**DOCUMENT 00 90 00  
ADDENDUM**

**ADDENDUM NO. [2]                      Date: January 5, 2022**

**RE:                      SCHOOL DISTRICT OF ABBOTSFORD  
ABBOTSFORD SCHOOL DISTRICT FEMA ADDITION  
510 WEST HEMLOCK STREET  
ABBOTSFORD, WISCONSIN 54405  
HSR PROJECT NO. 21027**

**3** FIRST FLOOR PLAN - ENLARGED  
1/4" = 1'-0"

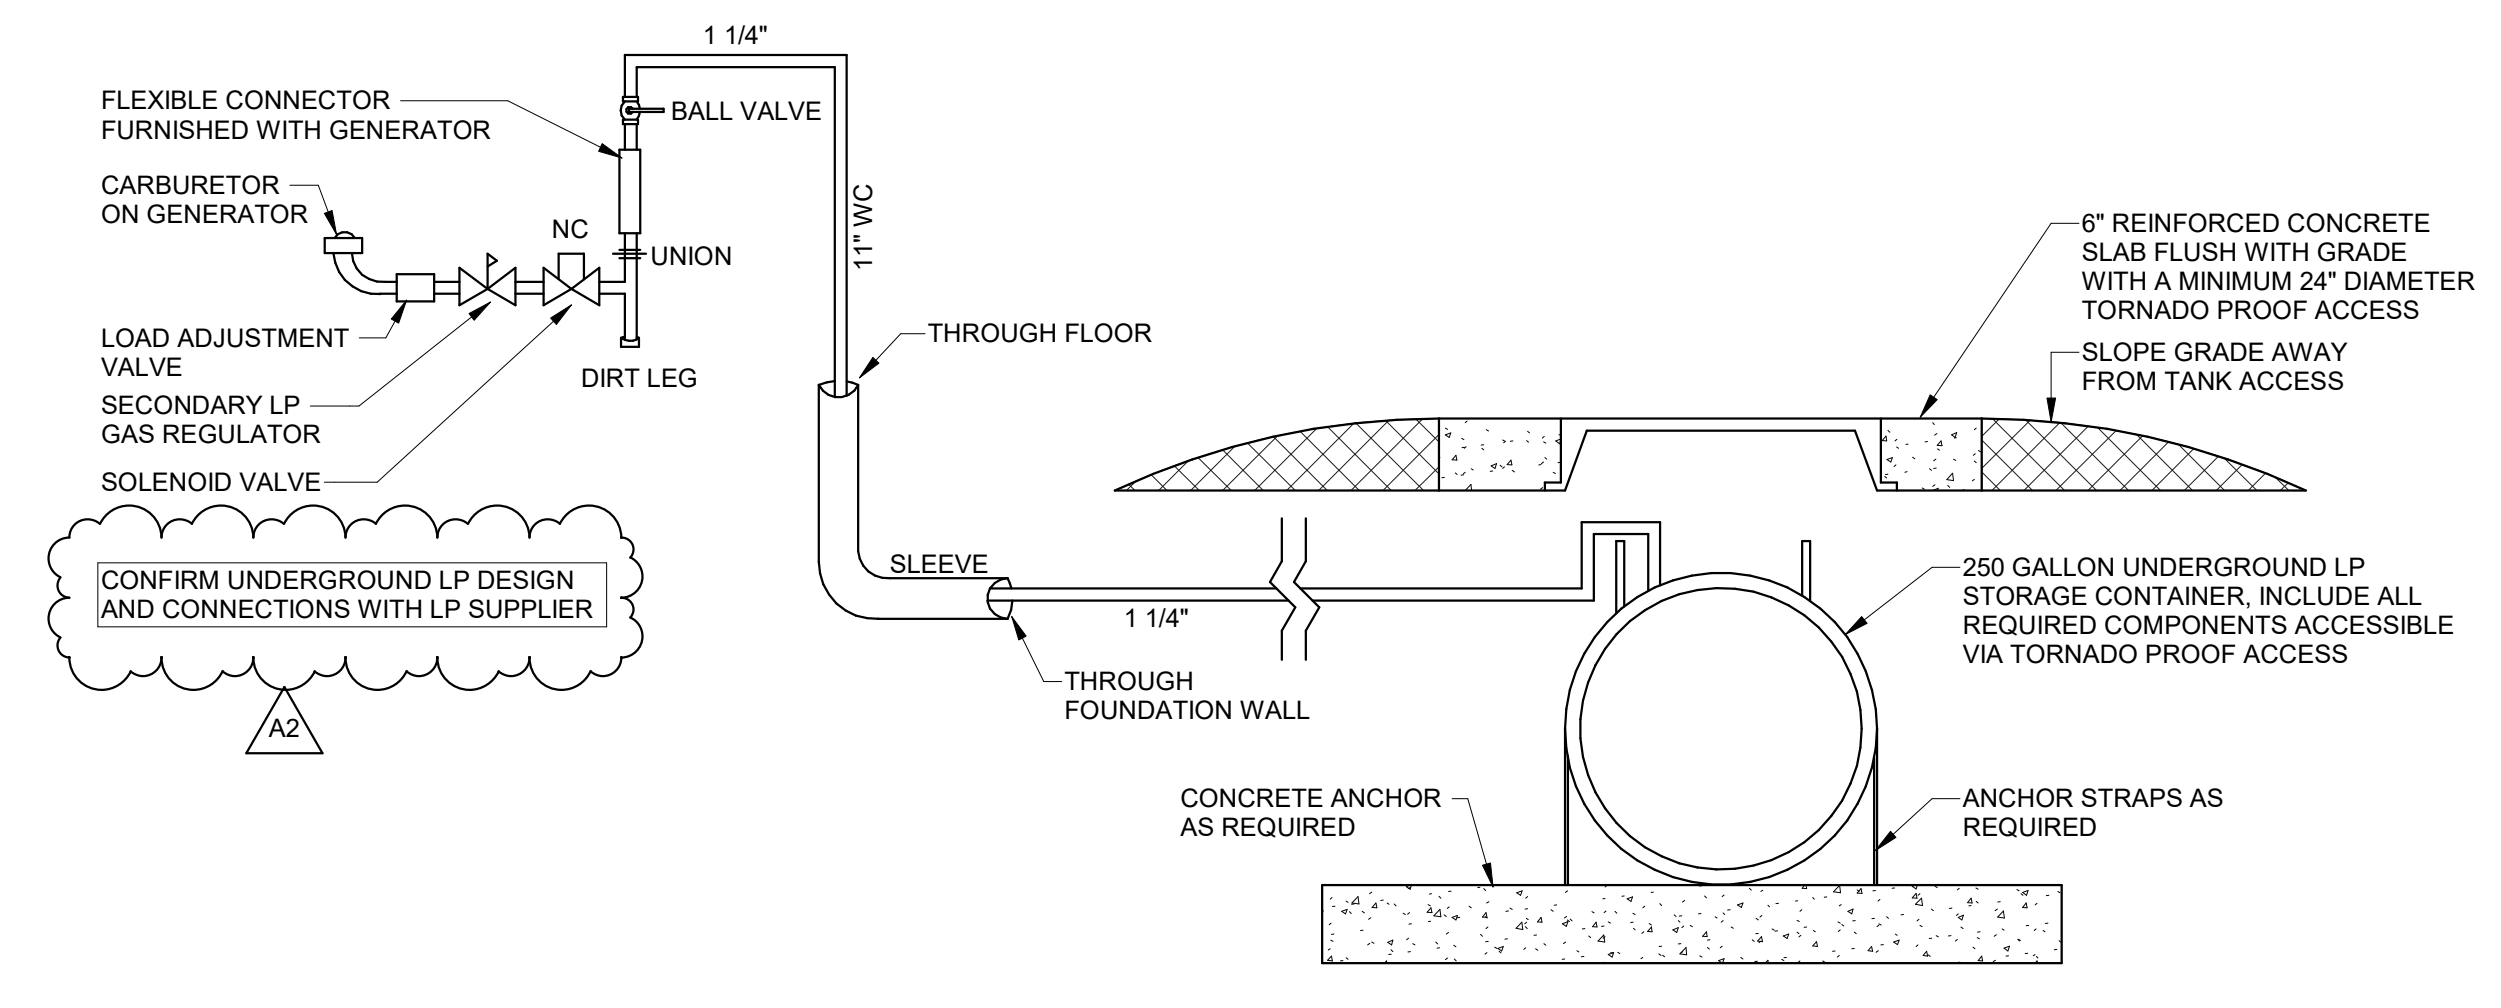
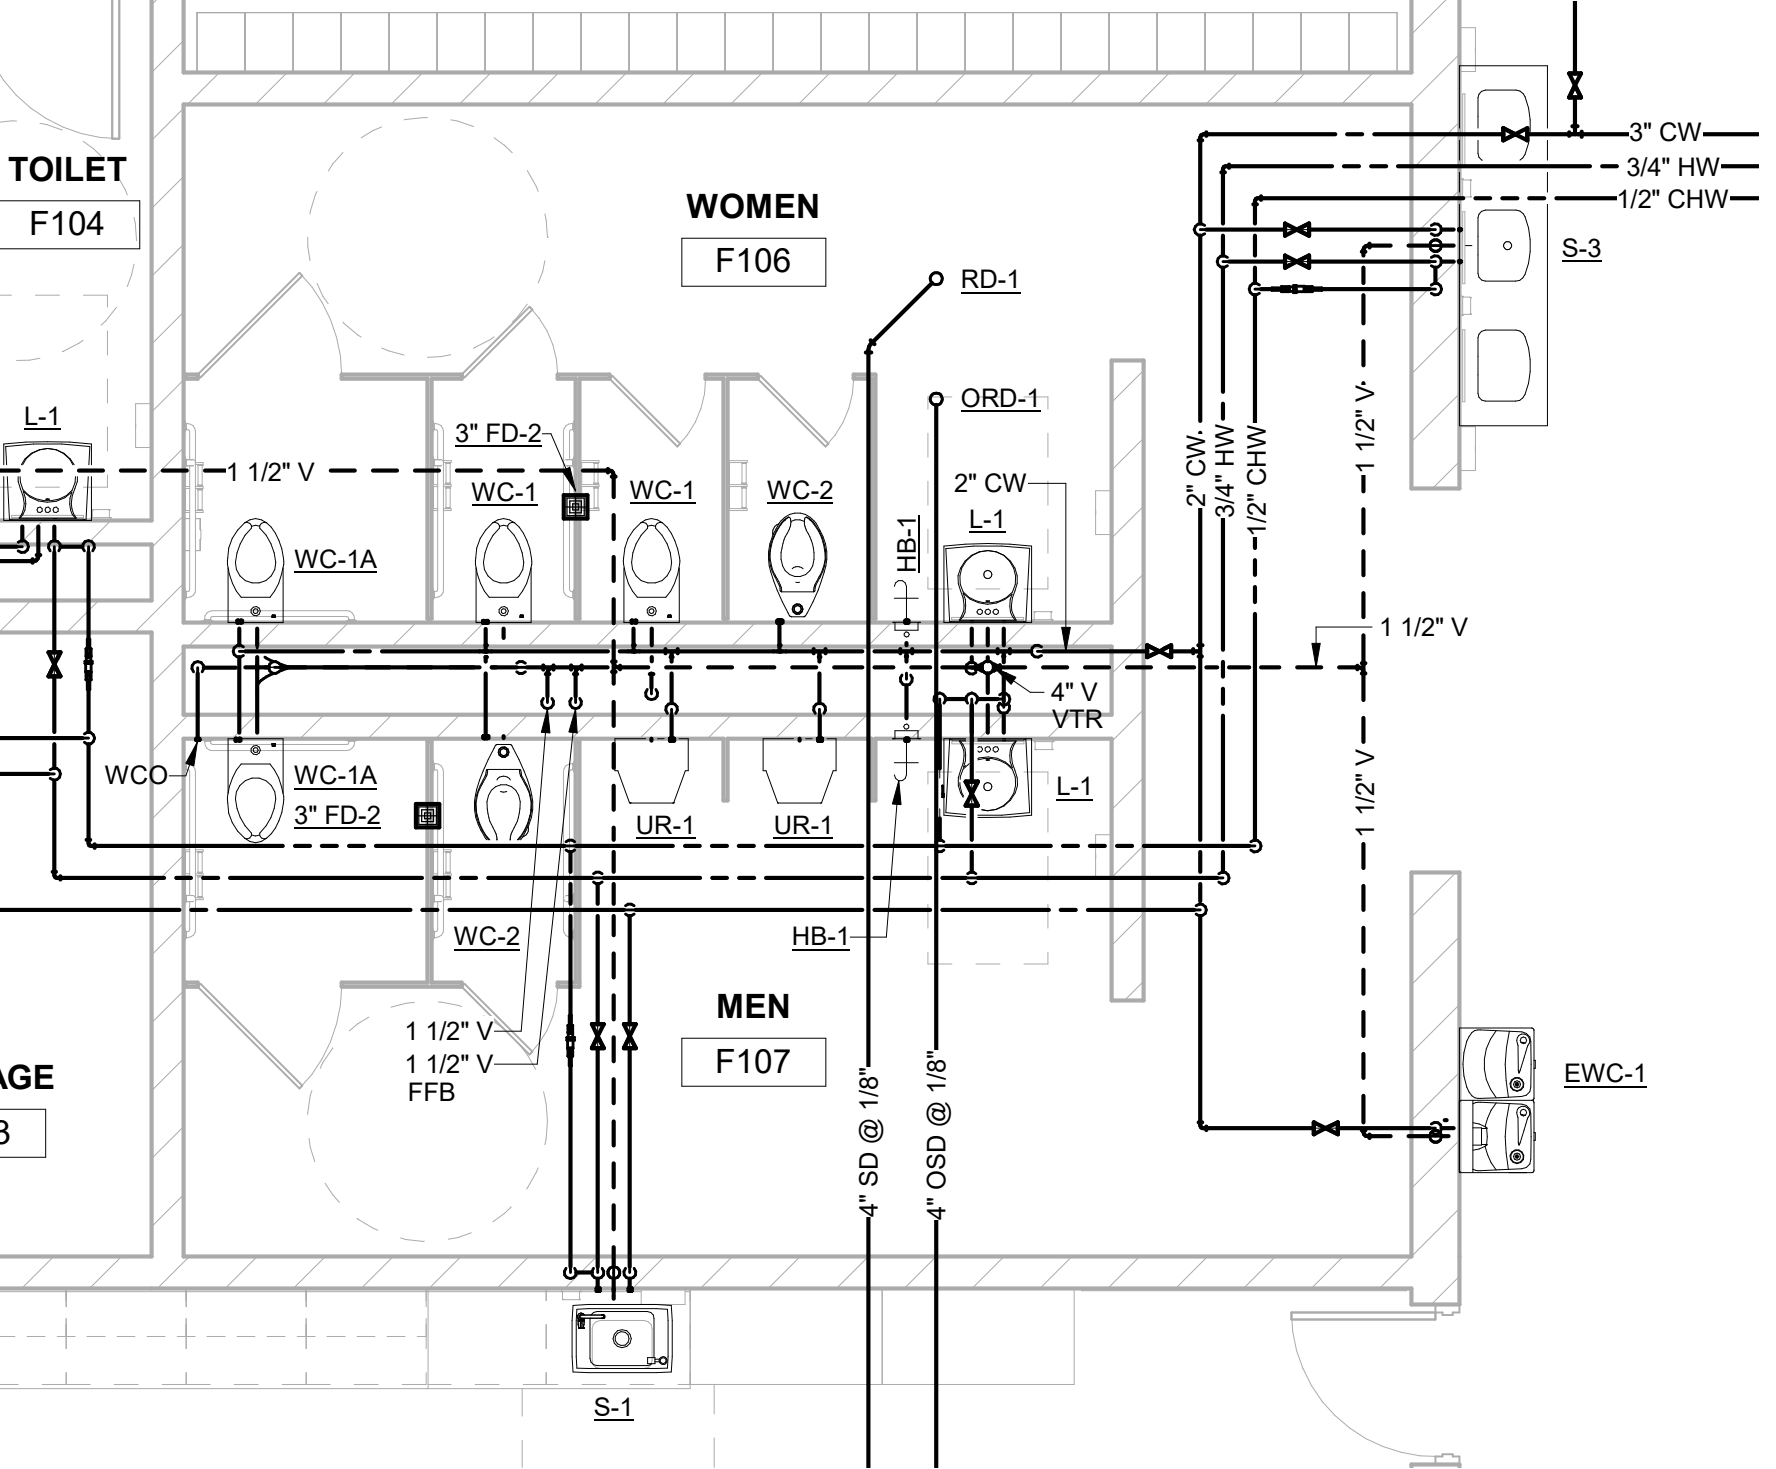
20. Sheet P101 FLOOR PLAN revised 30 x 42 sheet attached hereto.

- a. Revised sink designation from S-1 to S2.
- b. Added note regarding Cyclone roof penetrations.
- c. Added note regarding coordination with underground LP supplier.

**M100**

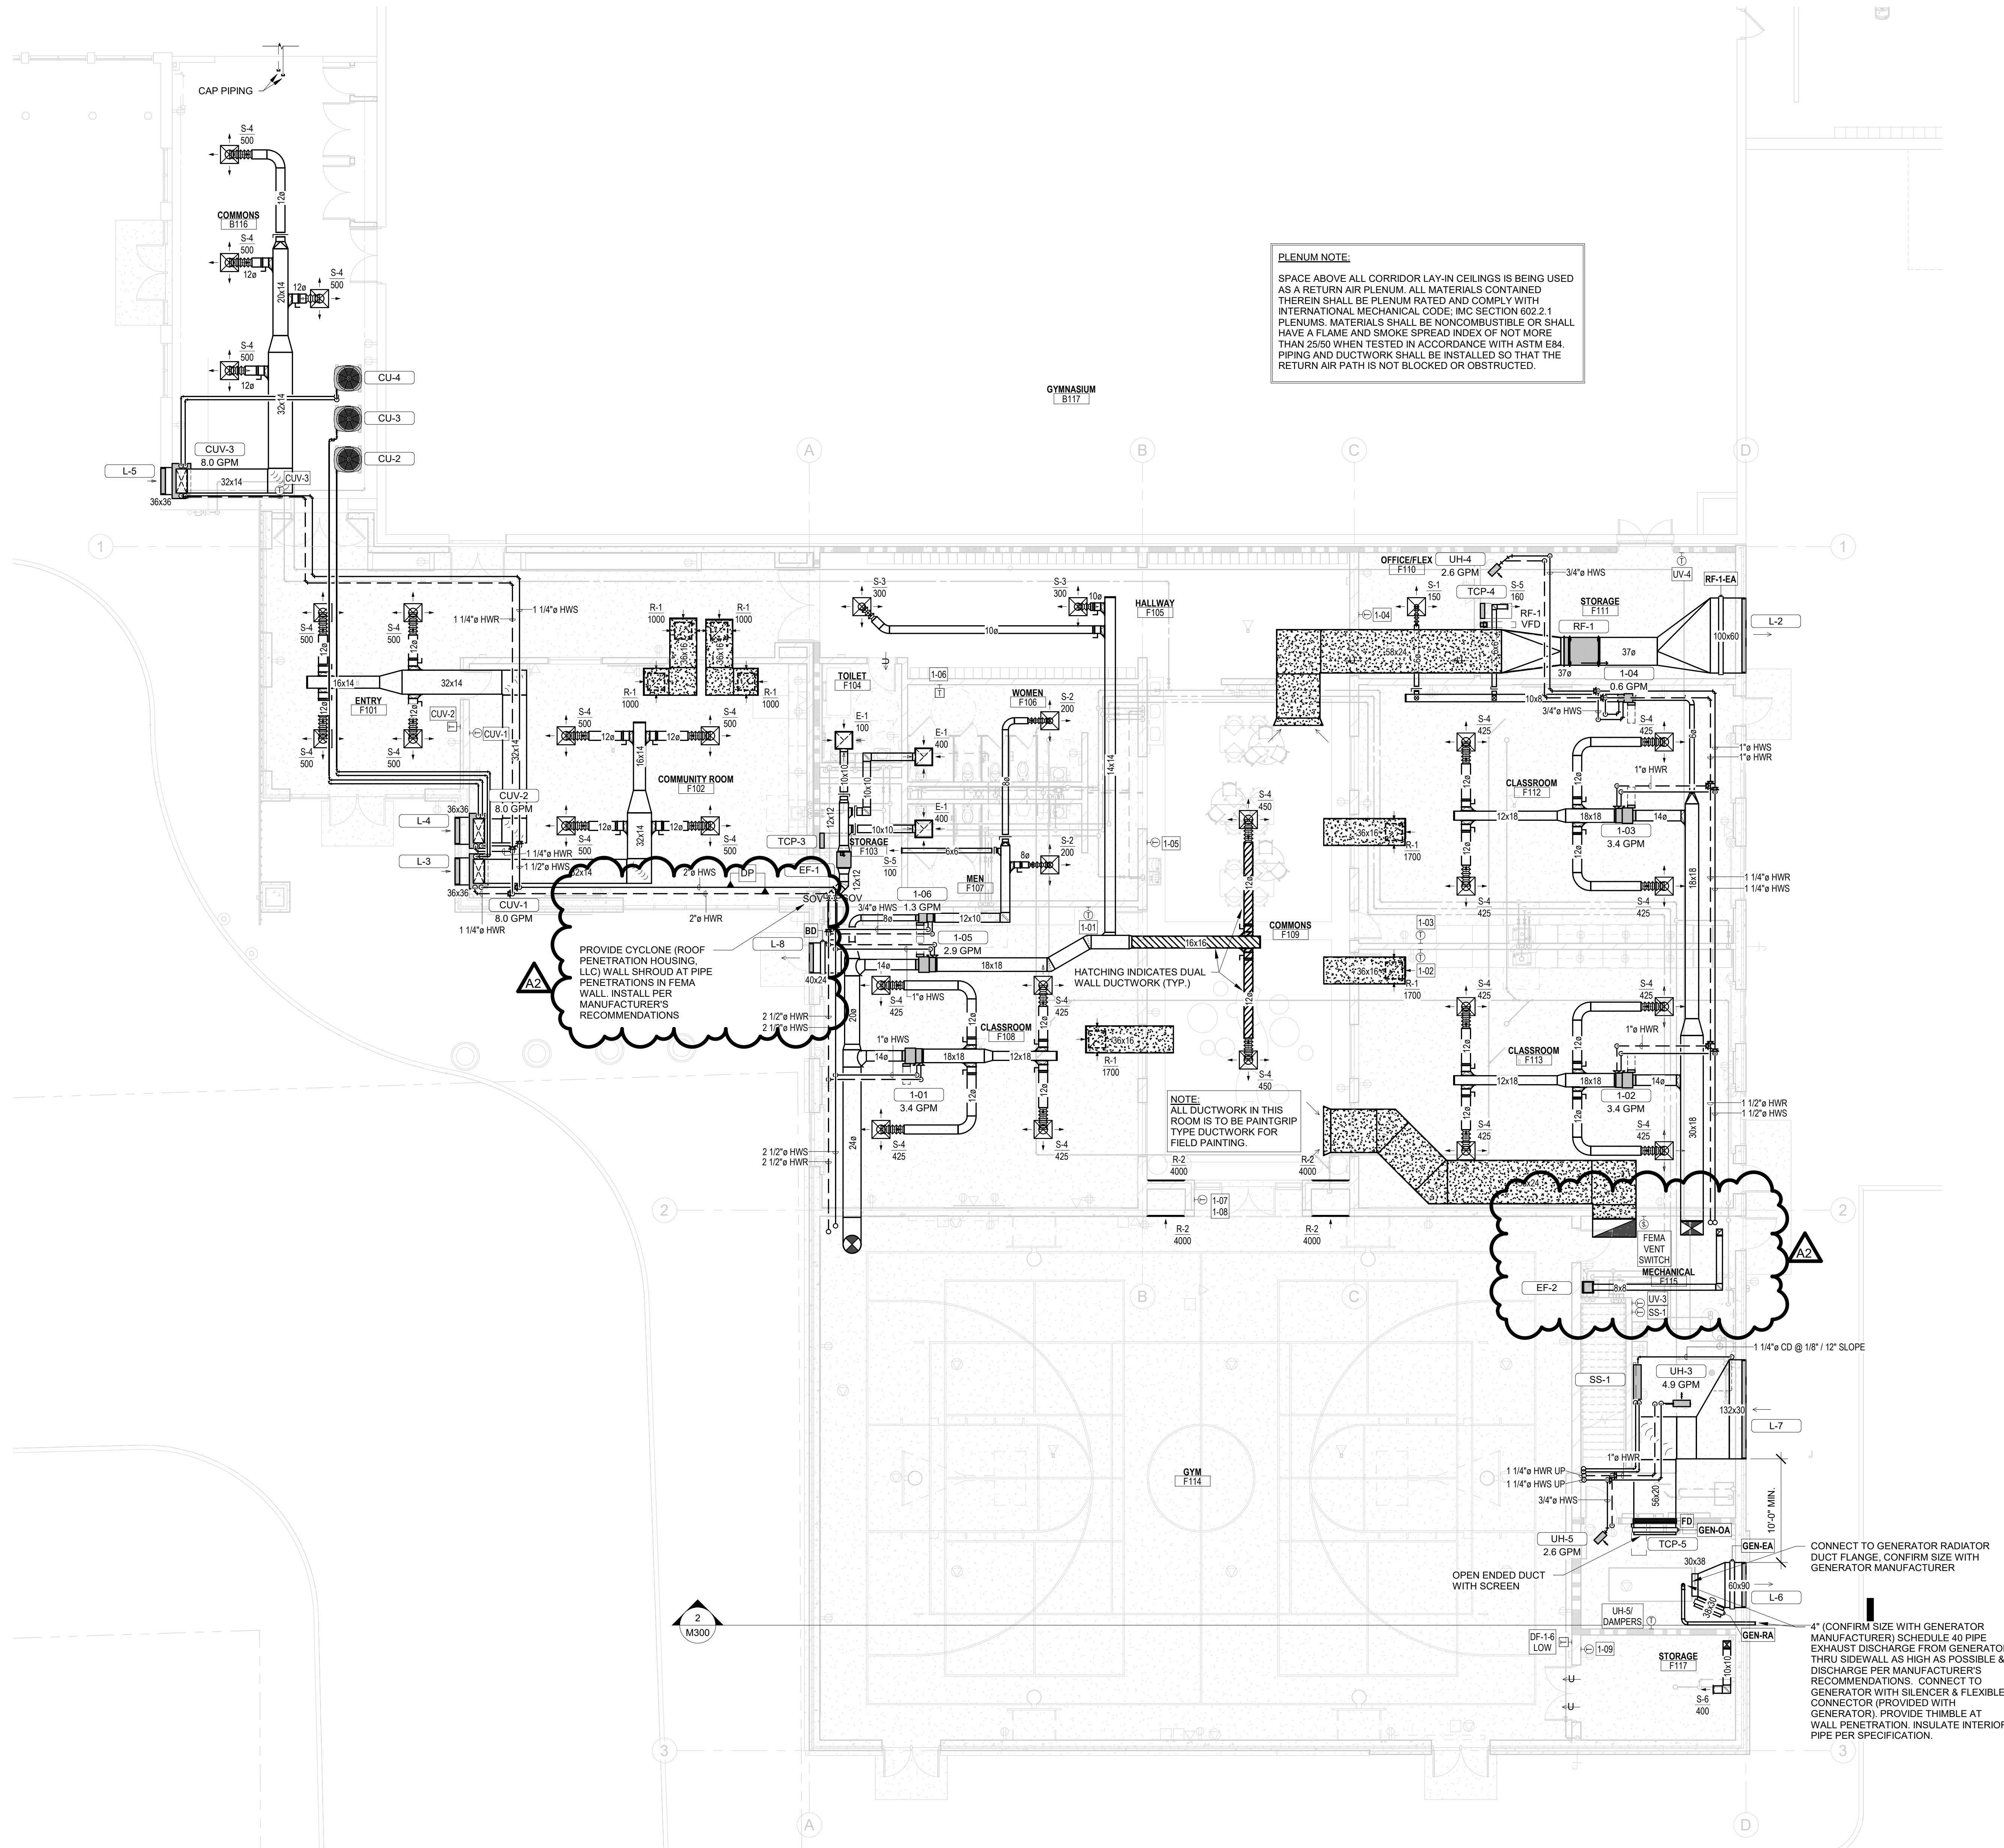
21. Sheet M100 FIRST FLOOR REMODEL PLAN revised 30 x 42 sheet attached hereto.

- a. Added FEMA Rated wall shroud for pipe penetrations at Storage F103.
- b. Added EF-2 fan serving Mechanical F115 mop basin.

PROVIDE CYCLONE (ROOF PENETRATION HOUSING, LLC) WALL SHROUD AT PIPE PENETRATIONS IN FEMA WALL. INSTALL PER MANUFACTURER'S RECOMMENDATIONS
